**M E M O R A N D U M**

**RE:** Water Right,  
File Nos. 4,451 & 27,607

## APPROVAL OF APPLICATION FOR CHANGE IN PLACE OF USE AND ORDER IN THE MATTER OF THE LOCATION OF THE AUTHORIZED POINTS OF DIVERSION WATER RIGHT, FILE NO. 4,451

**APPLICATION FOR APPROVAL TO  
CHANGE THE PLACE OF USE, THE  
POINT OF DIVERSION OR THE USE  
MADE OF THE WATER UNDER AN  
EXISTING WATER RIGHT**

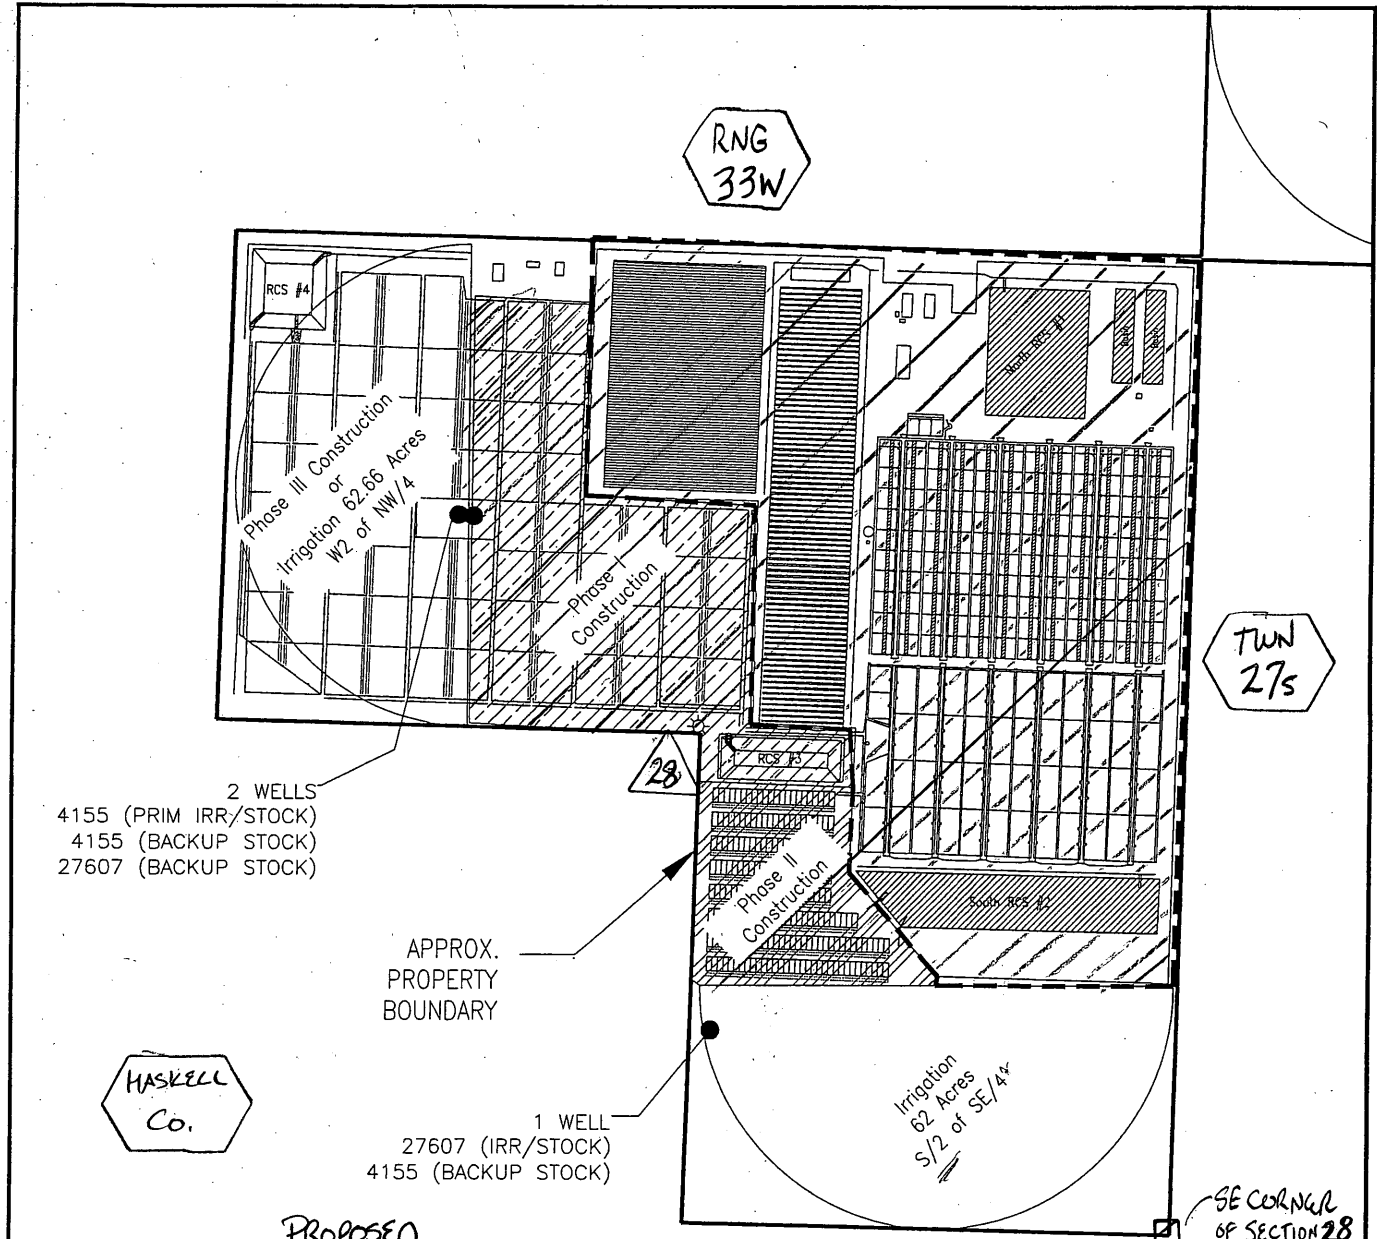
The modification to the proposed changes to comply with K.A.R. 5-3-23 may be completed by email. Attached are the portions of the documents needing the modification. The application table in part 5, listing the individual quarter acres and total acres to be irrigated should be updated. The map should show the modified acres as listed in the table. A legend has been added to the map to show the proposed irrigated acres as cross hatched lines.

The description of the stockwatering place of use in table 5 has been updated to our standard form and shown on the map.

Your updated/modified documents should be initialed and dated by you, the signer of the proposed applications for change.
